TECHNICAL SERVICE BULLETIN

Classification: EM22-003	Reference: NTB22-042	Date: May 24, 2022
-----------------------------	-------------------------	-----------------------

FAN BRACKET SERVICE INFORMATION

APPLIED VEHICLES: 2020 Titan/Titan XD (A61)

Figure 1

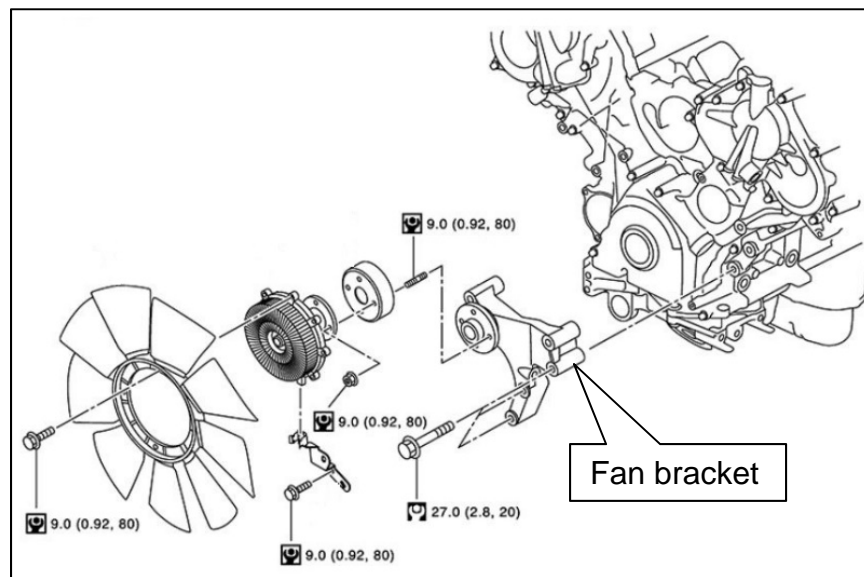
If the Fan Bracket on an **APPLIED VEHICLE** is replaced for any reason, replace it with the part number listed in **PARTS INFORMATION** on page 2. Follow the updated torque sequence, as shown in Figure 2 on page 2.

Figure 2

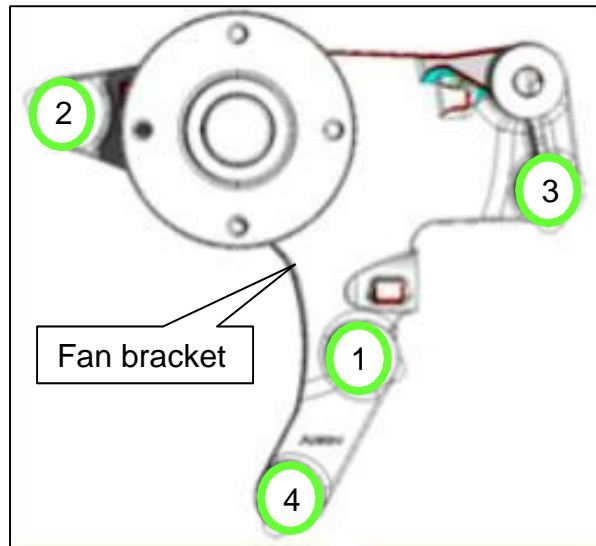
FAN BRACKET TORQUE SEQUENCE
